RE: S/D 99-54 -- One-Step Final Plat of HOSKINSON 2nd ADDITION

RE: S/D 99-54 -- One-Step Final Plat of HOSKINSON 2nd ADDITION

STAFF REPORT

CASE NUMBER: S/D 99-54 - HOSKINSON 2ND ADDITION**OWNER/APPLICANT:** Box Development, LLC, 128 S. Dellrose, Wichita, KS 67218**SURVEYOR/ENGINEER:** Austin Miller, P.A., 254 S. Laura, Suite 210, Wichita, KS 67211**AGENT:** John T. Arnold Associates, Attn: Don Arnold, Jr., 101 S. Market, Wichita, KS 67202**LOCATION:** Southwest corner of 37th St. North and Ridge Road**SITE SIZE:** 17.2 Acres**NUMBER OF LOTS**

Enclosure: Marked Copy of Plat

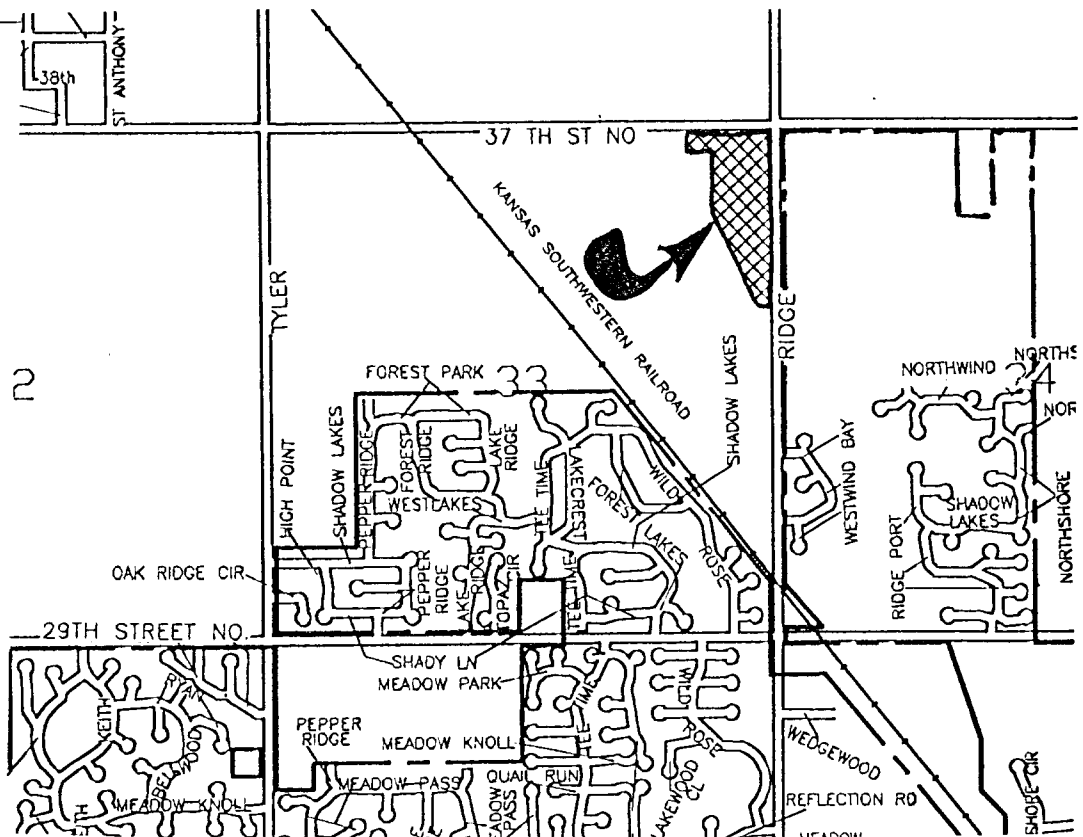
- C. The site is currently located outside of the Northwest Wichita Sanitary Sewer growth limits. The Applicant shall guarantee the extension of City water and sanitary sewer to serve the lots being platted. An additional utility easement is needed along the north line of Lot 4 or along the south line of Lot 2, for the sewer extension to Lot 9. .

- N. Dimensions need to be added for the west lines of Lots 1, 2, 3, 4, and 9; the north line of Lot 1, the south line of Lot 9 and the sewer easement on Lot 8.

- O. The location of all found and set monuments needs to be denoted.
- P. The platator's text shall reference the minimum building elevations and wall easements and shall also reference access controls as being dedicated to the "appropriate governing body".

- Q. The platator's text shall note the platting of "Lots and a Block".
- R. The legal description needs to be revised to accurately denote the bearings for the north and east line of the section.

- S. The location and elevation of on-site and off-site benchmarks should be provided.
- T. County Fire Department has requested an increase in width of the 30-ft access openings to 40 feet.

- CC. The representatives from the utility companies should be prepared to comment on the need for any additional utility easements to be platted on this property. **Southwestern Bell has requested additional easements.**
